Re: SWPPP Violations-Numerous-See list below eNOI NMR12AY23

- 1. Lots of trash all over the site.
- 2. Sediment in Derickson St.
- 3. Sidewalk culvert on San Pedro was unprotected and there was sediment leaving the site.
- 4. Mortar mess in the middle of the site. (mitigated)
- 5. Sediment in drive aisle at the north entrance not protected from entering the street.
- 6. Refer to e-mail dated 9-23-15 for additional items.

Broadstone Promenade SWPPP inspection

more pics promenade

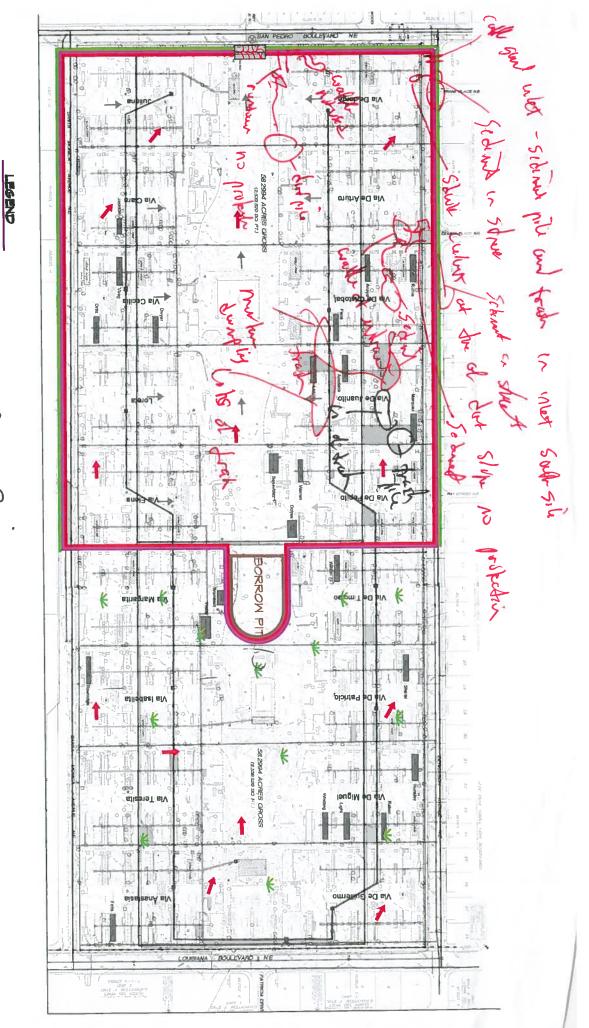
- 1. The large amount of trash on the site. If it isn't the trashiest I've ever seen it is a close runner-up.
- 2. Sediment in Derickson.
- 3. Sediment pile and trash in the cattle guard inlet. Should clean that while the traffic control is in place.

- 4. Sediment is leaving the site through the entrance on Derickson. A wattle should be place at the security fence inside.
- 5. The sidewalk culvert on Derickson near San Pedro was unprotected and there is a large unprotected dirt slope right next to it as well as extending far to the east.

- 6. Mortar mess in the middle of the site.
- 7. Concrete washout and trash in the material laydown area.
- 8. The rundown leading to San Pedro should have inlet protection/wattle.

- 9. There was sediment in the drive area and a dirt pile that was eroding towards the rundown. A smaller wattle (3"??) may work best here as it can trap sediment, yet allow high flows to go over it.
